Access Compliance Report

Public Rights-of-Way

Intersection ID: 12957	Main Street: HAMORTON_PL	Cross Street: PECAN_AV	Location: SE
ADA ID: 7204A9B7B0C8	Ramp Type: PerpDiag	Initial Pass/Fail: Fail	Overall Compliance: No
		Severity Score: 12.5

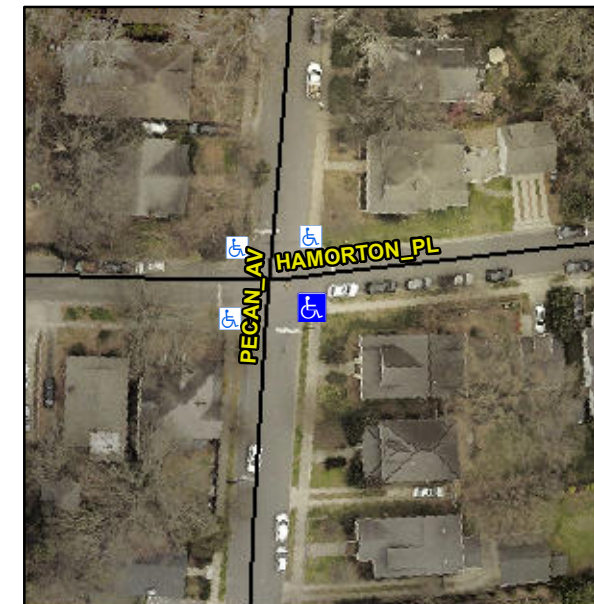
Not Found, R304.2.2

Compliance	Description	Data	Compliance	Description	Data
N/A	Ramp Length (in)	83.0	No	Ramp Slope (%)	8.4
Yes	Ramp Width (in)	63.0	Yes	Ramp XSlope (%)	1.5
N/A	Flare Type LT	N/A	N/A	Flare Type RT	N/A
N/A	Flare Slope LT (%)	N/A	N/A	Flare Slope RT (%)	N/A
N/A	Flare Traversable LT?	N/A	N/A	Flare Traversable RT?	N/A
N/A	Landing Length (in)	N/A	N/A	DWS Provided?	N/A
N/A	Landing Width (in)	N/A	N/A	DWS Contrast?	N/A
N/A	Landing Slope (%)	N/A	N/A	DWS Length (in)	N/A
N/A	Landing X Slope (%)	N/A	N/A	DWS Full Width?	N/A
N/A	Landing Curb? (Y/N)	N/A	N/A	DWS Offset (in)	N/A
N/A	Shared Landing?	N/A			
N/A	Gutter Ponding?	Yes	N/A	Gutter Slope (%)	N/A
N/A	Gutter Lip Ht (in)	N/A	N/A	Gutter X Slope (%)	N/A
N/A	Painted X Walk1?	No	N/A	Painted X Walk2?	No
	X Walk 1 Direction	To N		X Walk 2 Direction	To W
N/A	X Walk 1 Width (in)	N/A	N/A	X Walk 2 Width (in)	N/A
	X Walk 1 Slope (%)	0.9		X Walk 2 Slope (%)	1.2
	X Walk 1 X Slope (%)	3.5		X Walk 2 X Slope (%)	0.7

Remove & Replace Curb Ramp With Two New Directional Ramps or Equivalent.
